# Service Update

## 16189 Electronic Steering Column Lock Module Installed In Error

**Reference Number:** N162055980

**Revision Description:** The service procedure in this bulletin has been updated. Please discard all copies of 16189.

4254524

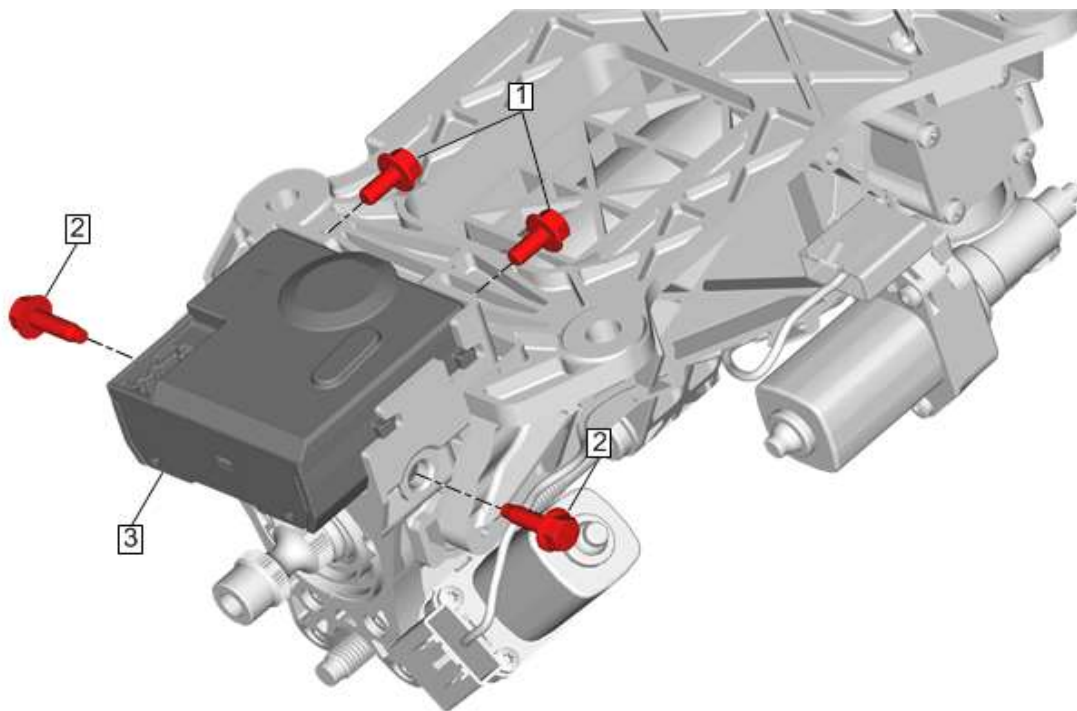
3. Inspect for the presence of the steering column lock control module (3).
  - If the steering column lock control module is NOT present, no further action is required. Proceed to step 5.

**Note:** Do NOT install a replacement module. Remove the steering column lock control module if it is present and DISCARD it.

- If the steering column lock control module is present, remove the steering column lock control module and DISCARD. Refer to *Steering Column Lock Control Module Replacement* in SI.
4. Center the steering angle sensor. Refer to *Steering Wheel Angle Sensor Centering* in SI.
5. Install the instrument panel lower trim panel insulator - left side. Refer to *Instrument Panel Lower Trim Panel Insulator Replacement - Left Side* in SI.
6. Close the driver door.
